Economic Commission for Europe**Inland Transport Committee****World Forum for Harmonization of Vehicle Regulations****Working Party on Passive Safety****Forty-eighth session**

Regulation No. 94 (Frontal Collision)**Proposal for Supplement 1 to the 02 series of amendments****Submitted by the expert of the European Commission***

Paragraph 6.2.1., amend to read:

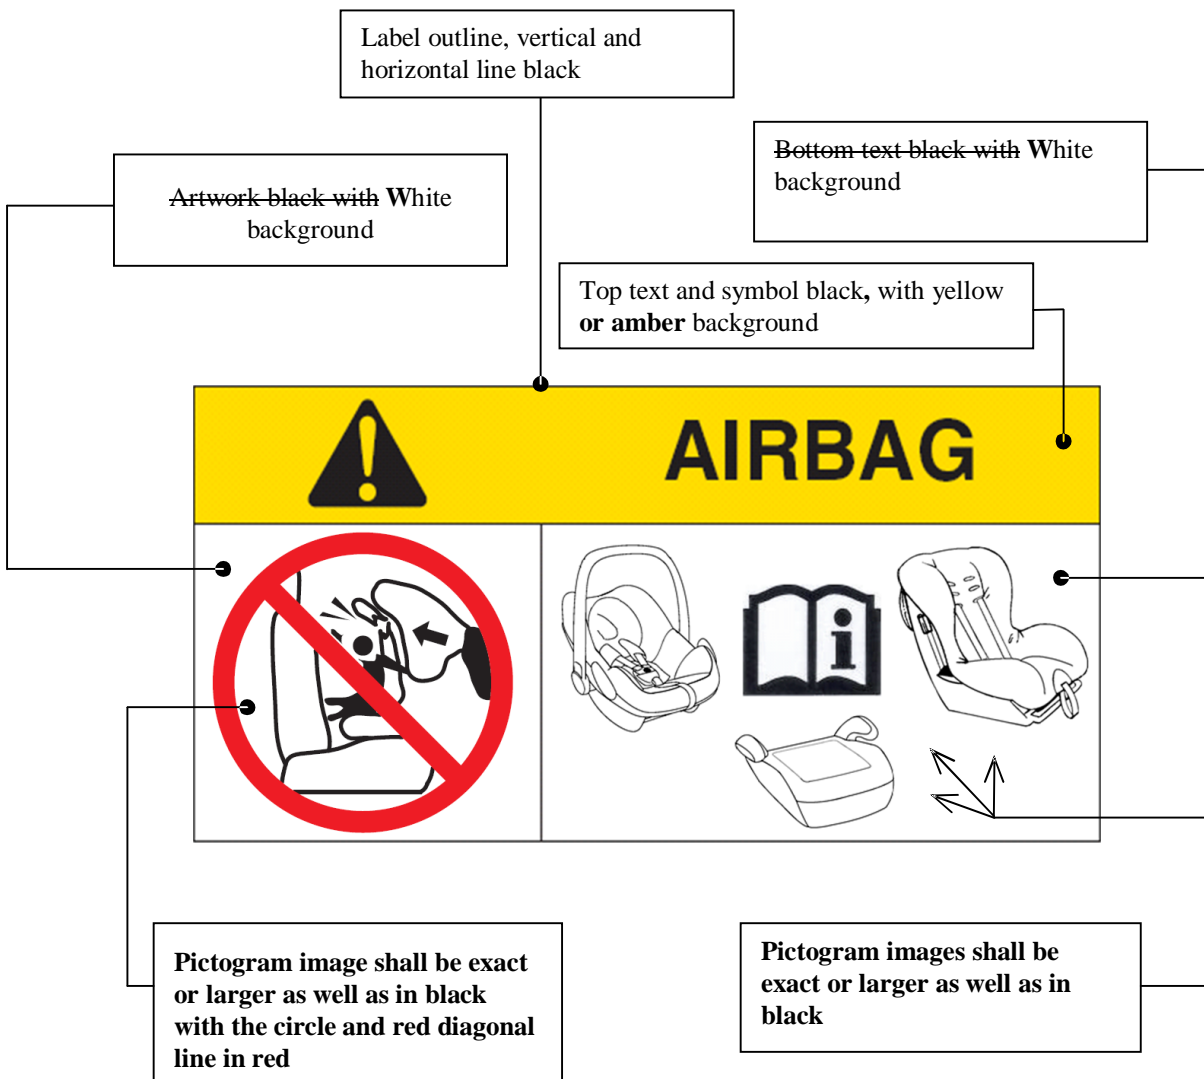
“6.2.1. As a minimum, this information shall consist of a label containing **clear warning pictograms and text warning** as indicated below.

The overall dimensions shall be **at least** 120 x 60 mm or the equivalent area; as a **minimum**.

The label shown above may be adapted in such a way that the layout differs from the example above; however, the ~~text~~ content shall meet the above prescriptions.”

3. It is expected that the comprehension of the proposed warning label, with the message conveyed by means of pictogram images rather than detailed text, is at least equivalent to that of current warning labels, incorporating the detailed text, as present in vehicles which are available on the market today.

5. The size of the warning label should remain at least 120 x 60 mm, as the size proposed in working document ECE/TRANS/WP.29/GRSP/2010/12 is not sufficient, which was clarified in Informal document No. GRSP-47-04/Rev.1.

6. The images of the different kinds of child seats and booster seats (including non-rearward facing child seats) are included to make the vehicle operator unambiguously aware that this warning concerns child restraint systems in general and indicates clearly to refer to the instruction manual. It can be assumed that it would always be beneficial if the instruction manual is referenced by the vehicle operator when any kind of child seat is about to be installed in the vehicle.
